Addendum No. 2  
Regional Carrizo Project - Schertz Parkway Pump Station  
SAWS Job No. 10-8617  
SAWS Solicitation No. B-11-061-RA

## **ADDENDUM NO. 2**

March 19, 2012

- A. The purpose of this addendum is to issue revisions to the plans and specifications for the Regional Carrizo Project - Schertz Parkway Pump Station (SAWS Job No. 10-8617; SAWS Solicitation No. B-11-061-RA).

**C-352**  
Sheet: 98 of 130  
Bar Measures 1 inch

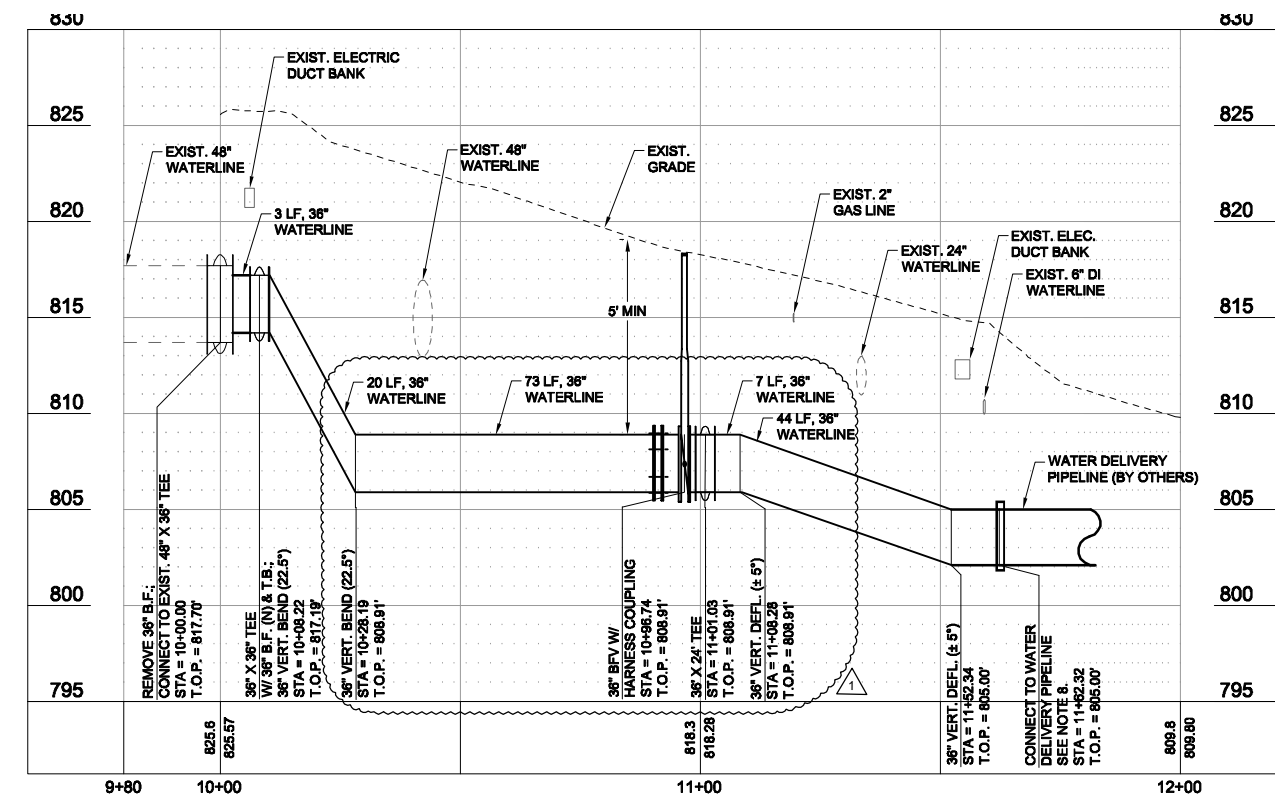
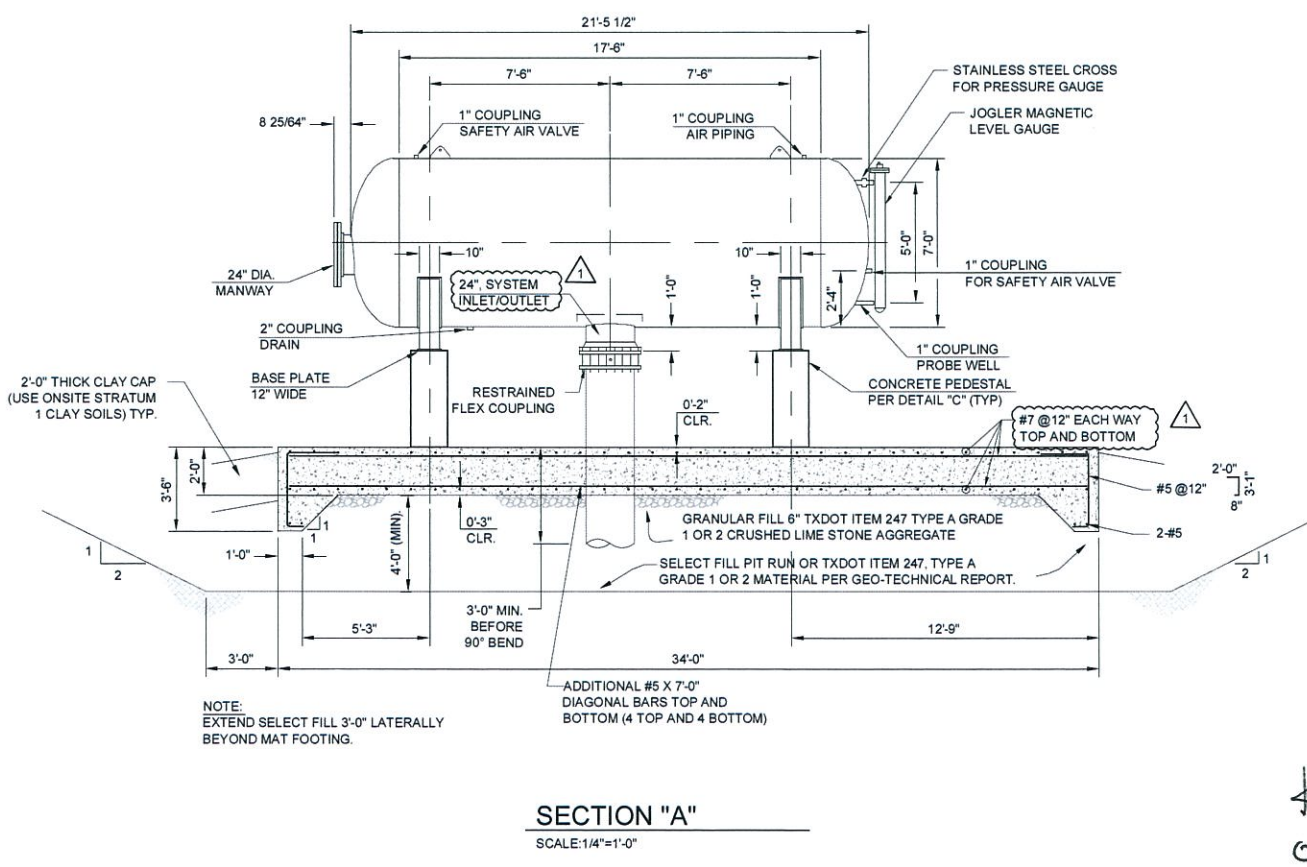
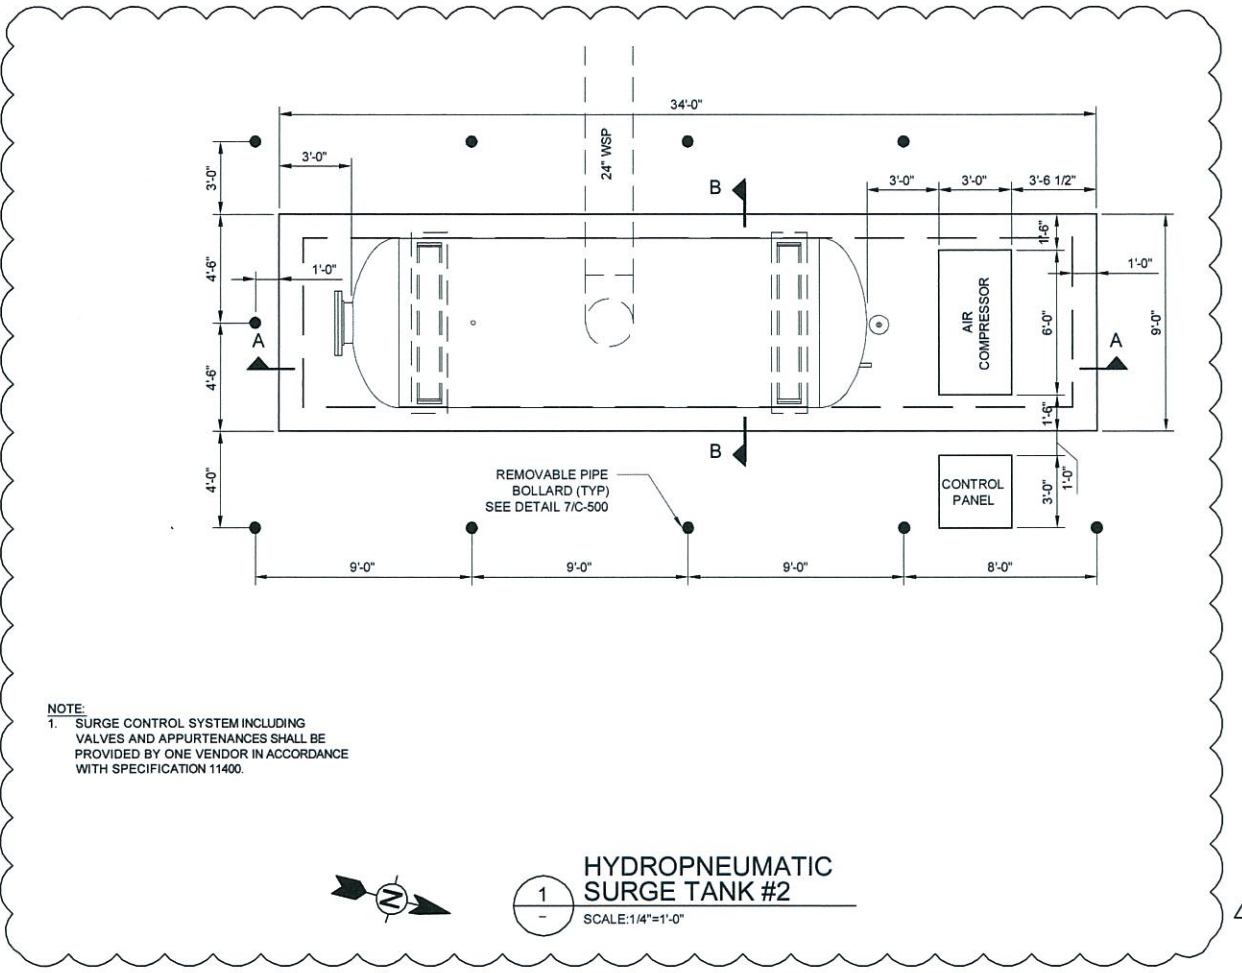
- E. Sheet C-352 (98 of 130)
4. Revise location of yard piping for new location of Surge Tank #2 as indicated in the revised Sheet C-352 included in this Addendum No. 2. Changes are indicated with revision clouds.

**M-151**  
Sheet: 100 of 130  
Bar Measures 1 inch

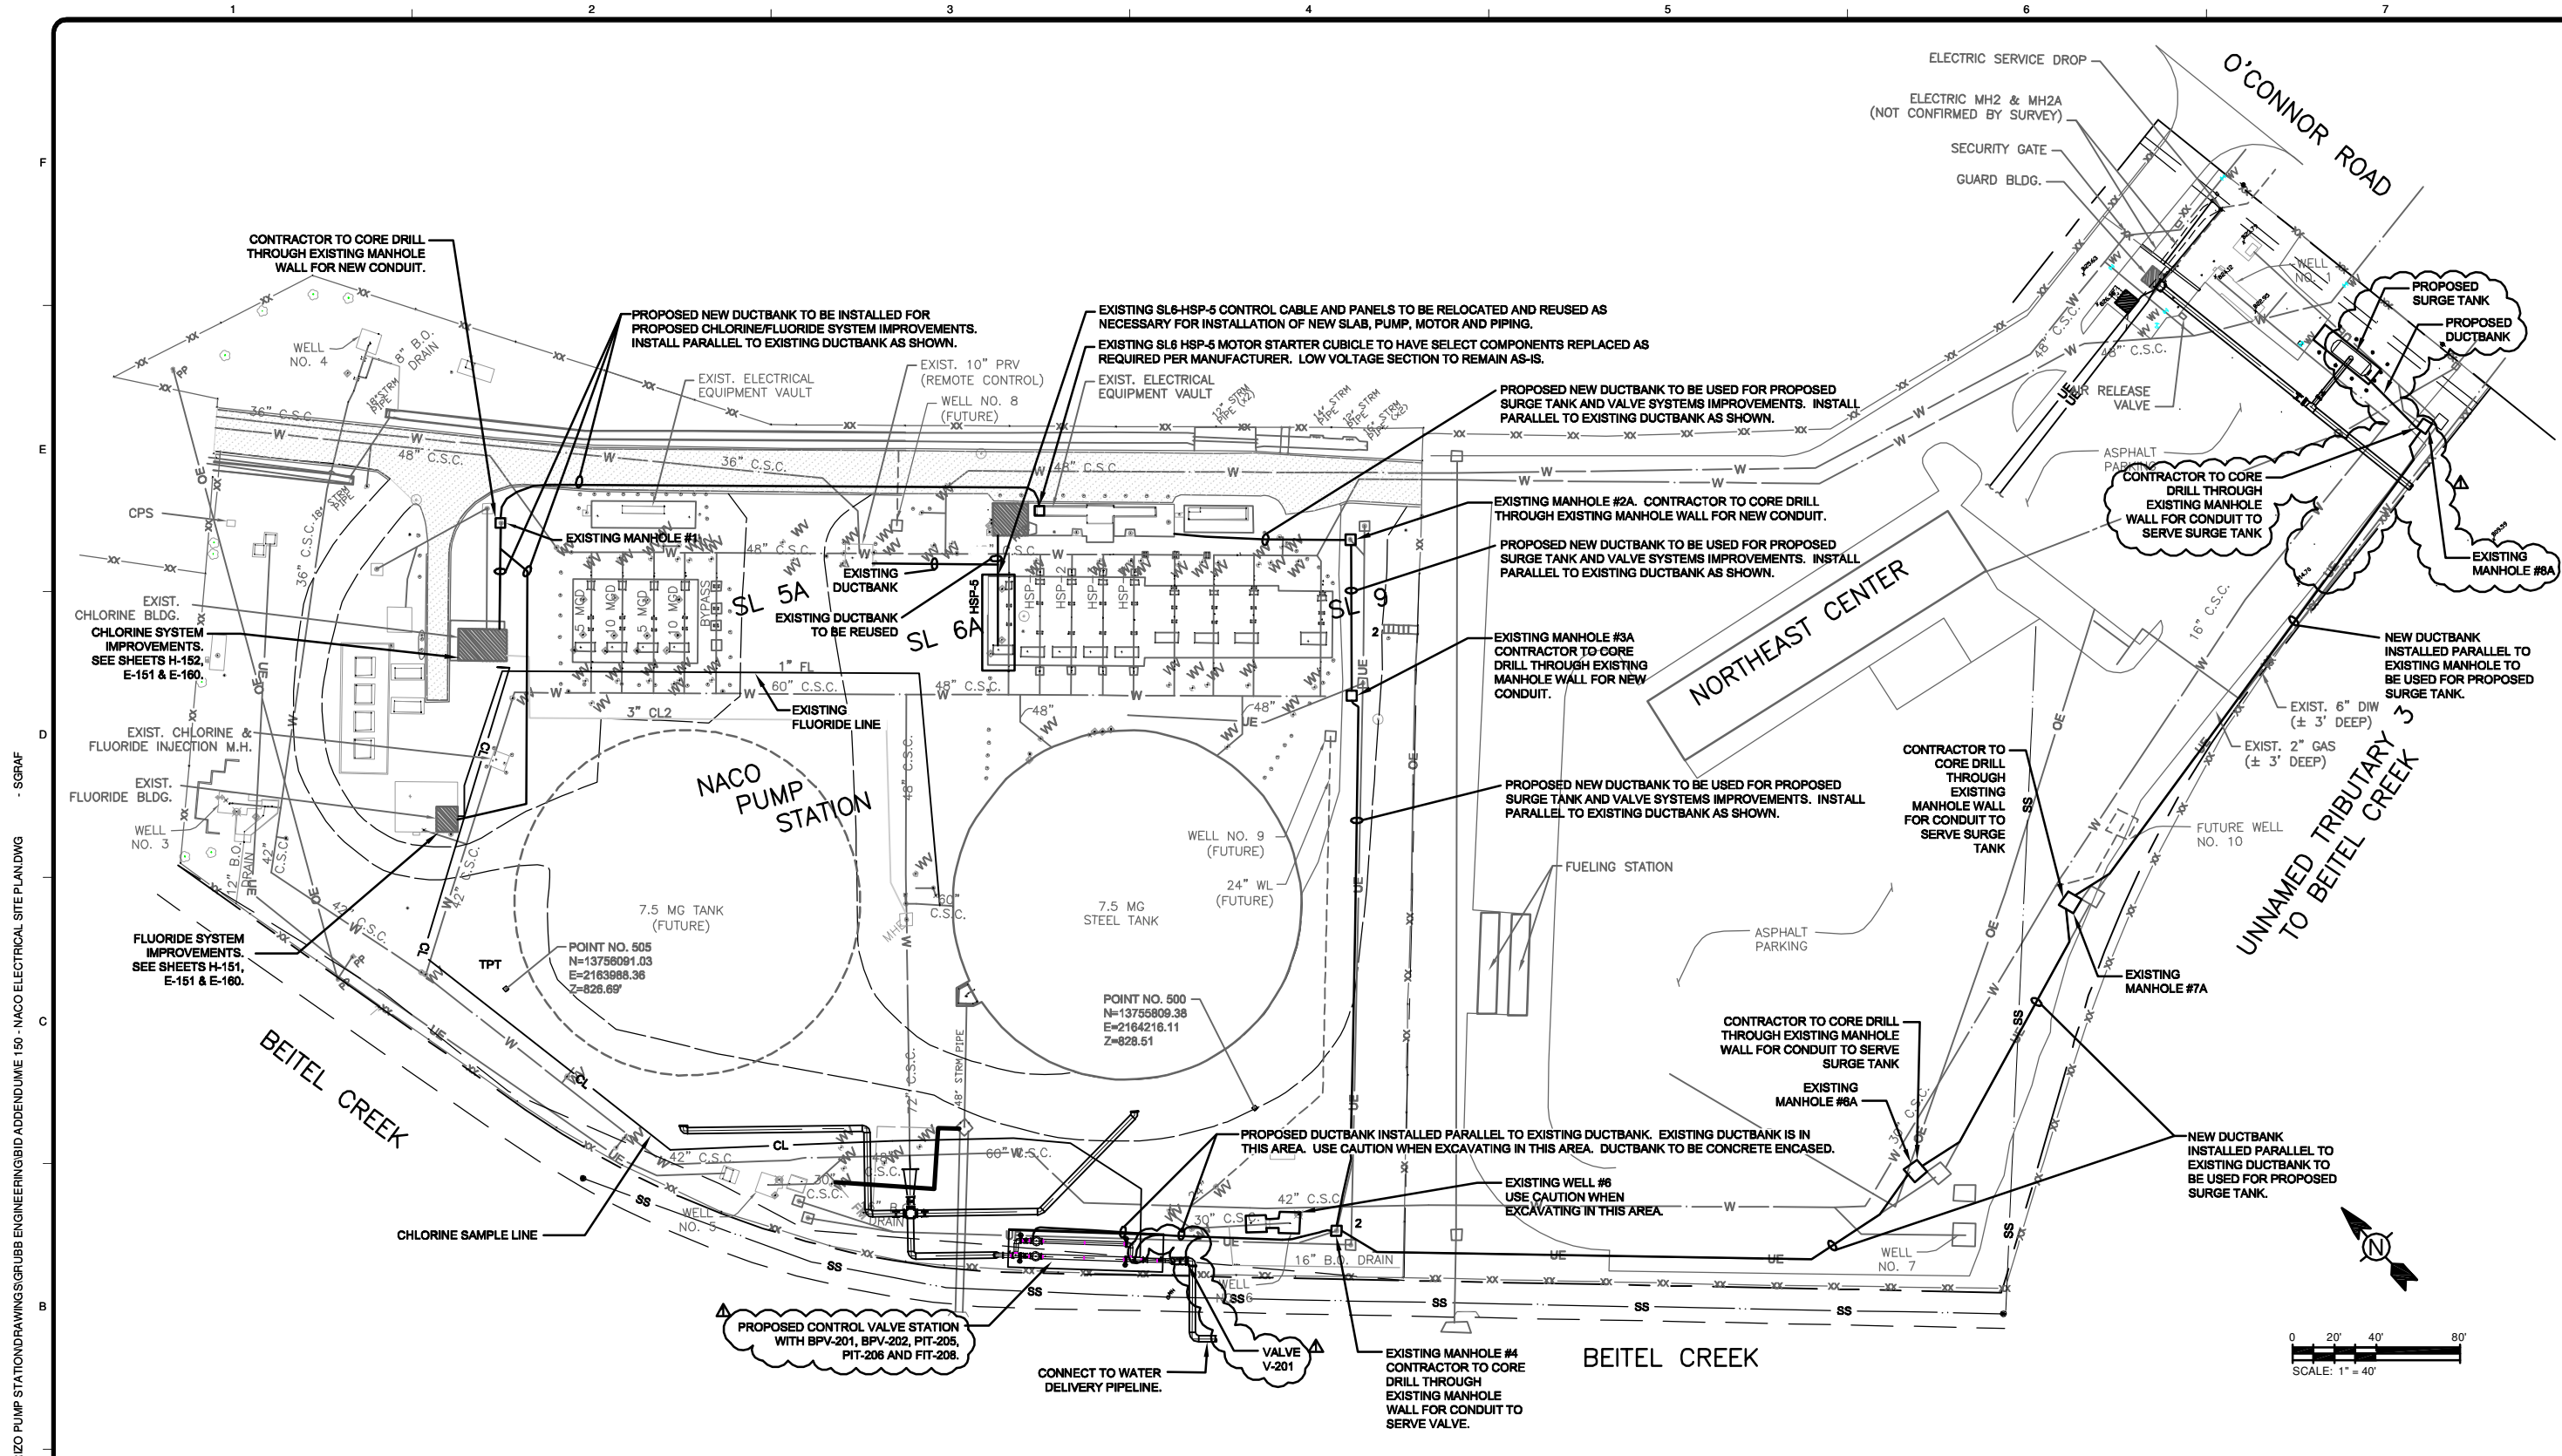
- F. Sheet M-151 (100 of 130)

5. Revise concrete footing and orientation of concrete pad for new location of Surge Tank #2 as indicated in the revised Sheet M-151 included in this Addendum No. 2. Changes are indicated with revision clouds.

**SAN ANTONIO WATER SYSTEM**  
 REGIONAL CARRIZO PROJECT  
 SCHERTZ PARKWAY PUMP STATION  
**NACO ELECTRICAL SITE PLAN**

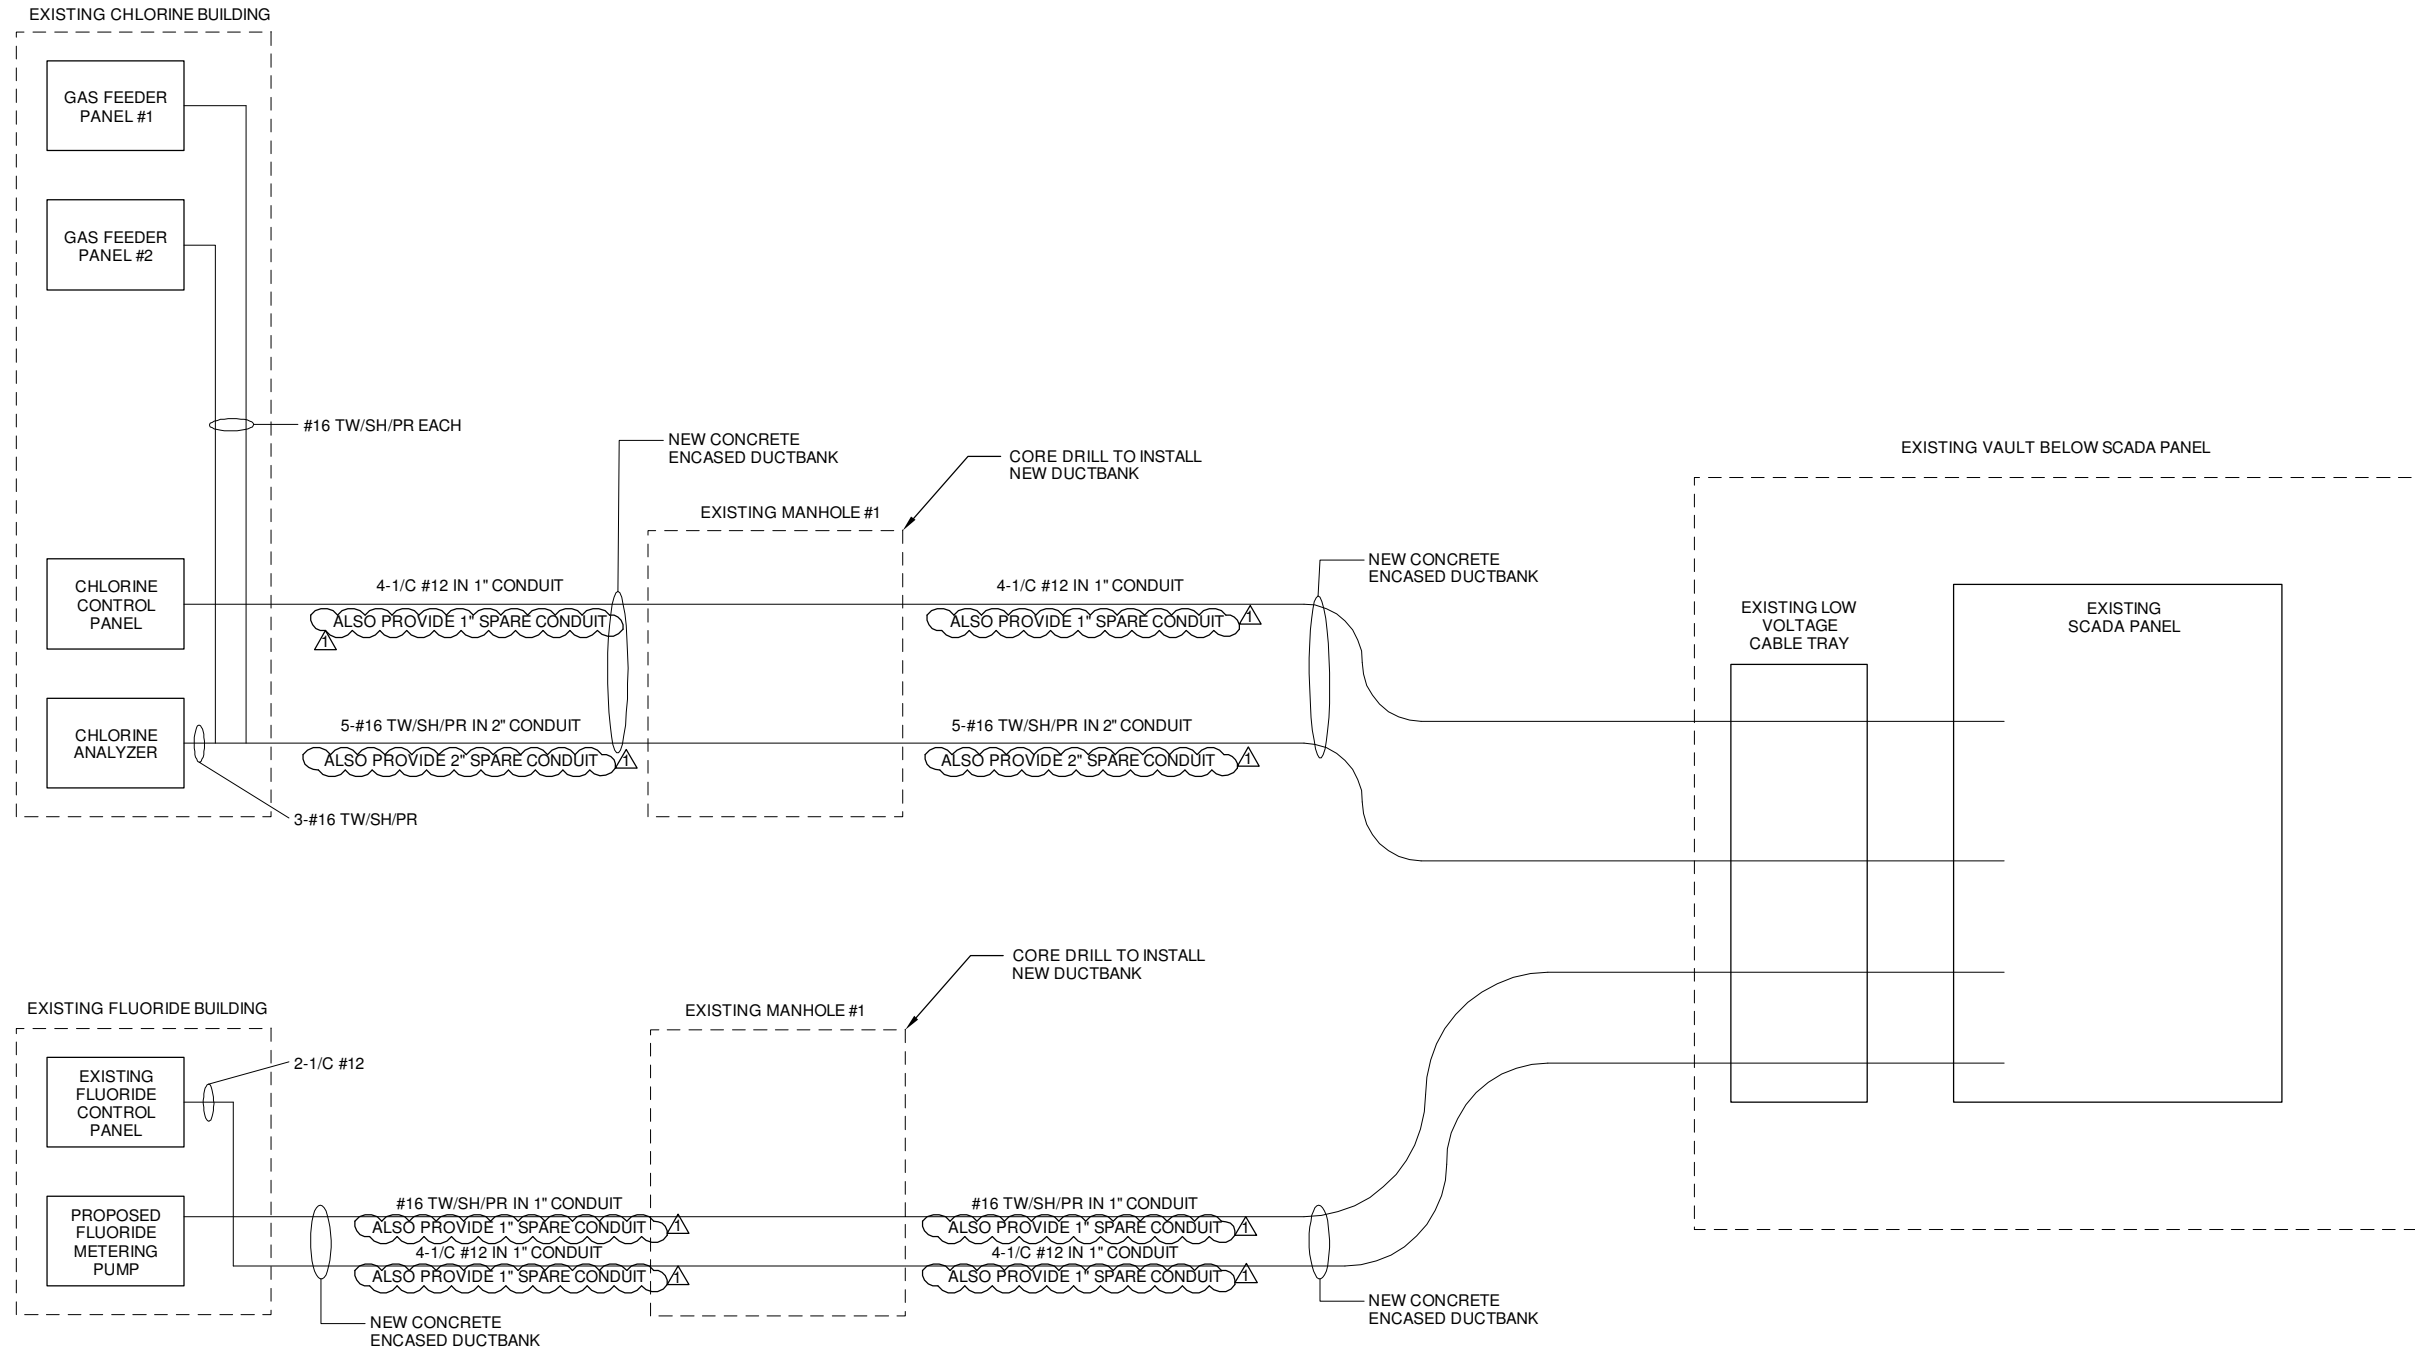
- G. Sheet E-150 (115 of 130)
6. Replace Sheet E-150 with new Sheet E-150 included in this Addendum No. 2. Changes are indicated with revision clouds.
- H. Sheet E-151 (116 of 130)
